Re: Public Comments on FPA No. 2819391

Re: **Comments on Forest Practice Application 2819391**
Lake Cavanaugh, Skagit County, Washington

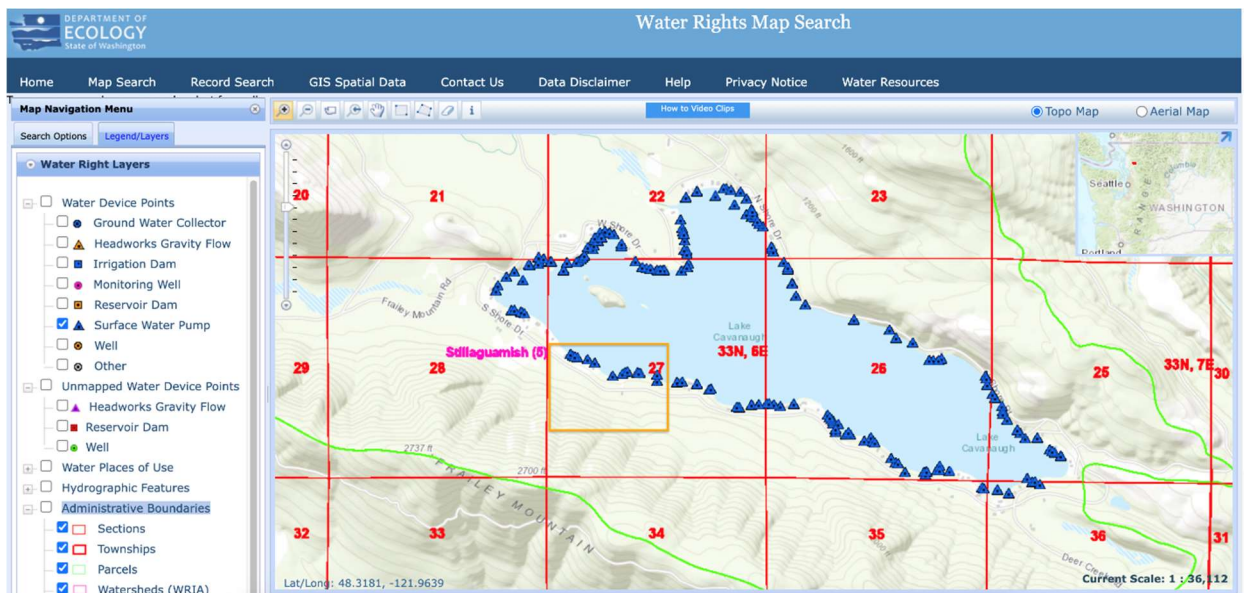
Id. at 5. “Large debris flows with large logs will very likely become jammed at a bridge crossing at [the proposed bridge over Stream #2]. This will alter the flow path of the debris flows out of the channel increasing the risk to down slope properties that are located away from the stream path and also potentially causing a larger debris dam failure downstream of the bridge location.” *Id.* at 4. In sum, as stated by Mr. McShane:

Removal of trees on the alluvial fan will increase the risk of debris flows traveling further down the alluvial fan and increase the risk of debris flows with large logs impacting properties and public resources on the lower reaches of the alluvial fan. The removal of trees also will increase the risk of a channel avulsion impacting properties and public resources lower on the fan surface. Placing a permanent bridge across an area where debris flows are expected to flow increases the risk of channel blockage during a large debris flow event resulting in an increase to the risk [of] down fan properties and public resources.

Figure 12 from Icicle report

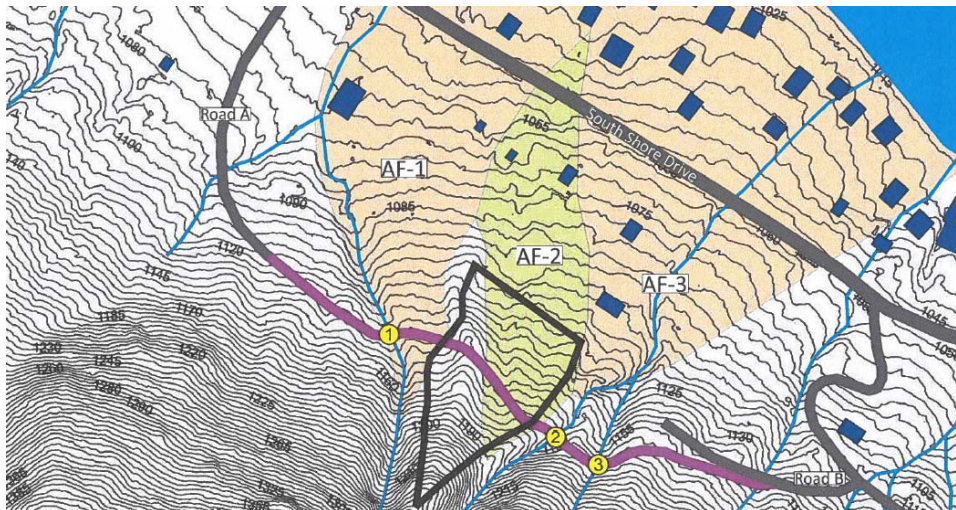
The geotechnical report (Icicle Creek Engineers, 2023) identifies three alluvial fan areas: AF-1, AF-2 and AF-3. The report indicates that AF-1 and AF-3 are active alluvial fan areas. I concur with that assessment based on my on the ground observations of both AF-1 and AF-3 and my interpretation of the geology of the area and lidar bare earth imagery of the fans.

Lidar bare earth imagery of AF-2 and Stream 2

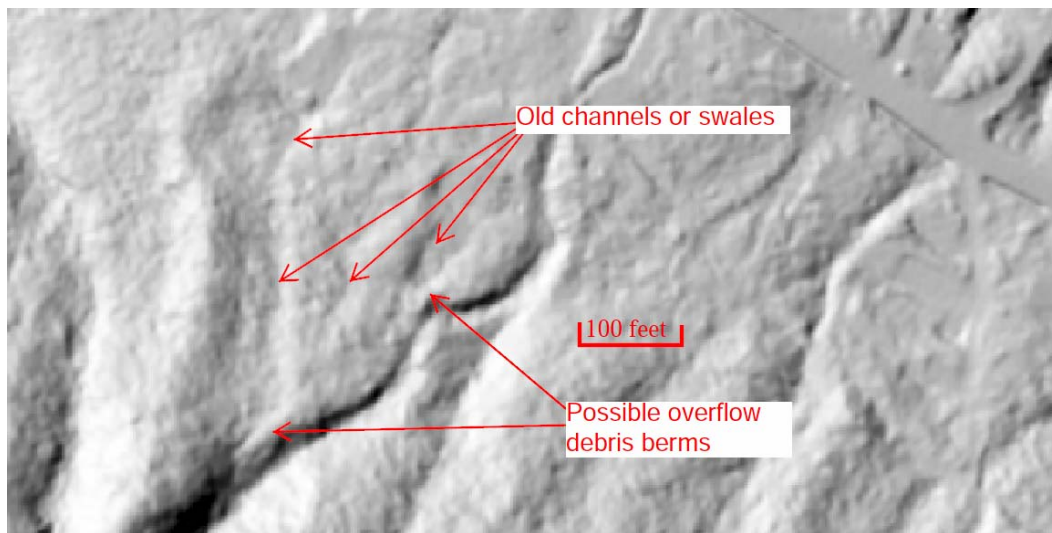
AF-2 is essentially part of the same alluvial fan as AF-3. Icicle has interpreted AF-2 as a relict alluvial fan on page 9 of their report:

1. Lidar bare earth imagery shows that the surface of AF-2 shows what appear to be three swales or old channels on the fan area surface. These swales are not described in the report and suggest that stream channels occupied this surface in the past. The lidar also indicates features that appear to be overflow berms – a typical feature of debris flow deposition on alluvial fans.
